Service information

This remark is valid for following Sidem parts:

21278 R / 21279 R / 21674 R / 21675 R

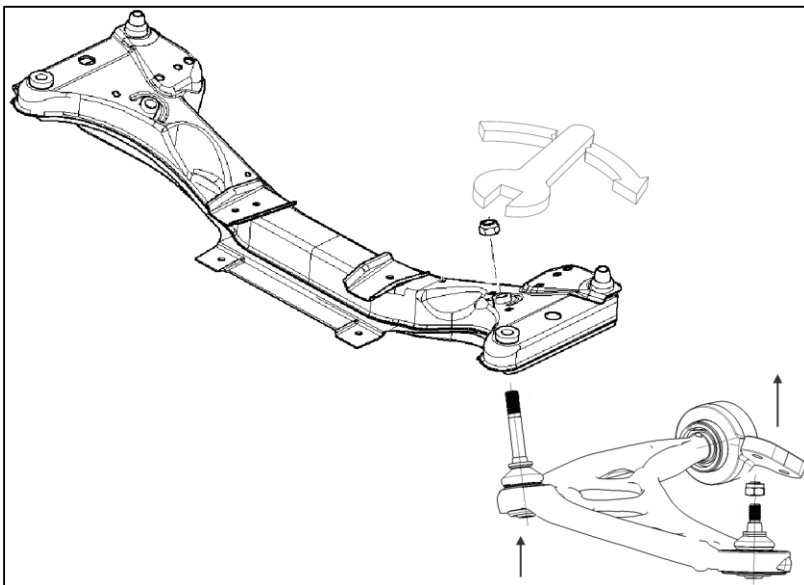
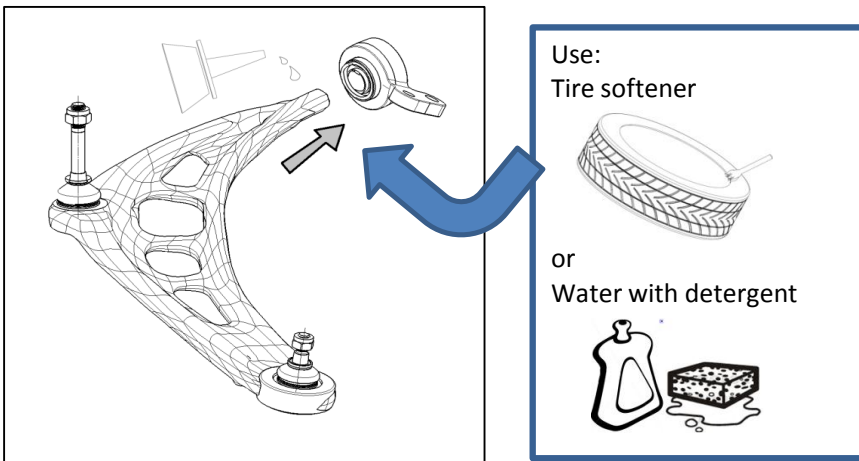
! Avoid early wearing of the silent blocks by following the correct placement procedure !

Always replace silentblock(s)! (821628)
Replace both arms when improved version is installed!

1. moisture pin and mount in silent block
2. fix arm
